# CITY OF ALBUQUERQUE

RE: 5501 Bell SE Grading Plan

Engineer's Stamp Date 6/21/17 (File: L18D082)

Based on the information provided in your submittal received 6/22/17, the Grading Plan cannot be approved for Building Permit until the following are addressed:

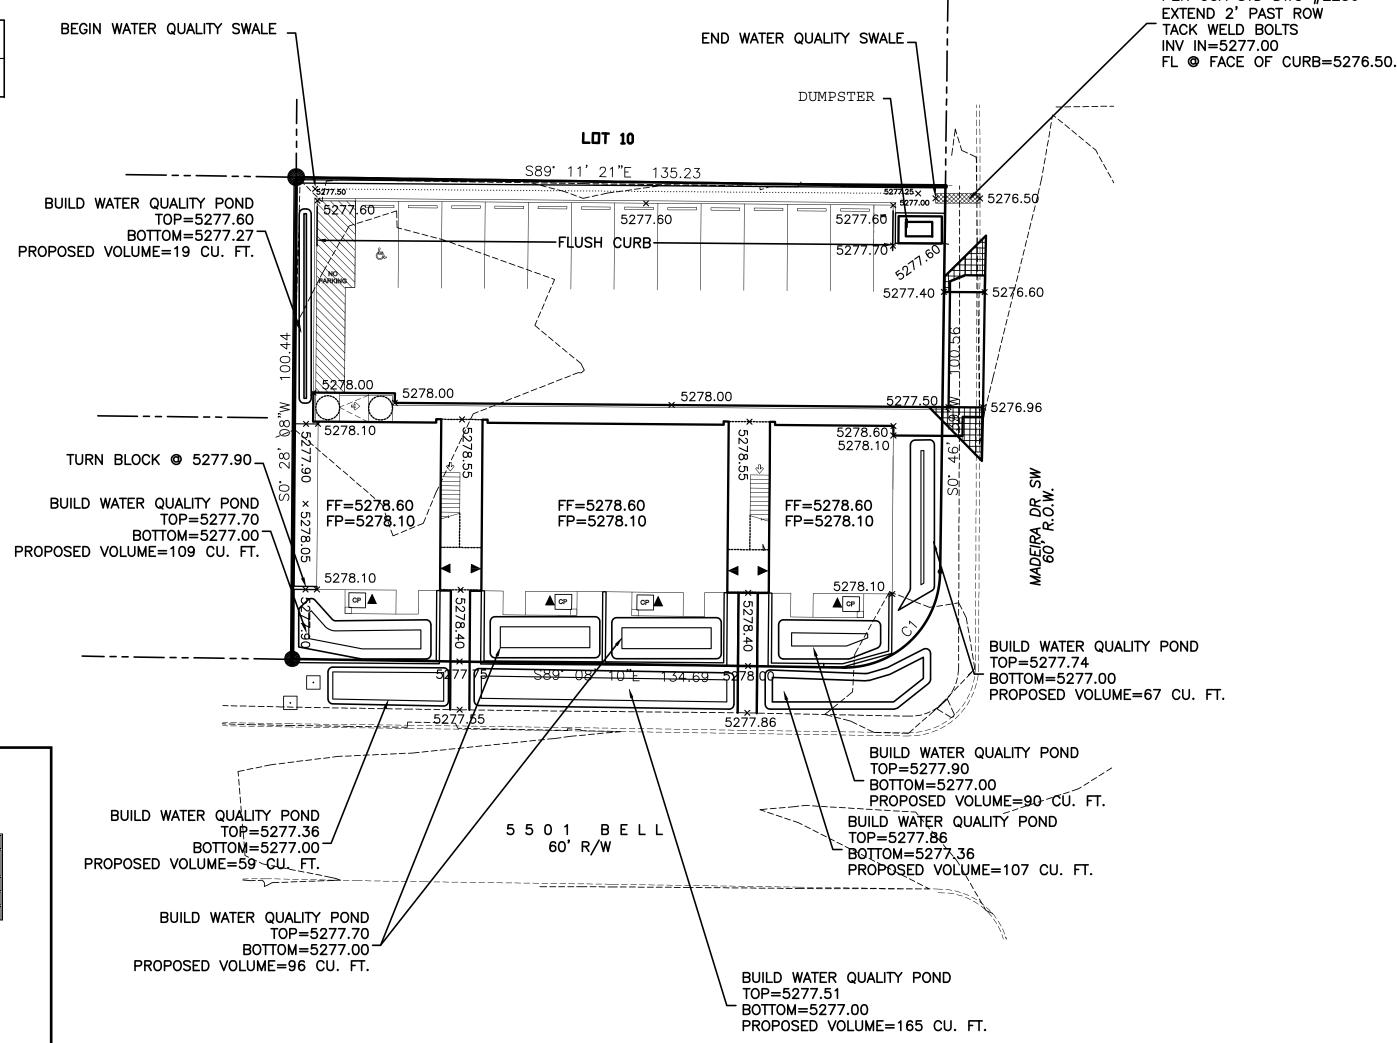
- 1. This site requires a Flood Plain Permit, submitted to Rudy Rael (<u>rrael@cabq.gov</u>), for grading work in the flood plain.
- 2. Provide project benchmark information.
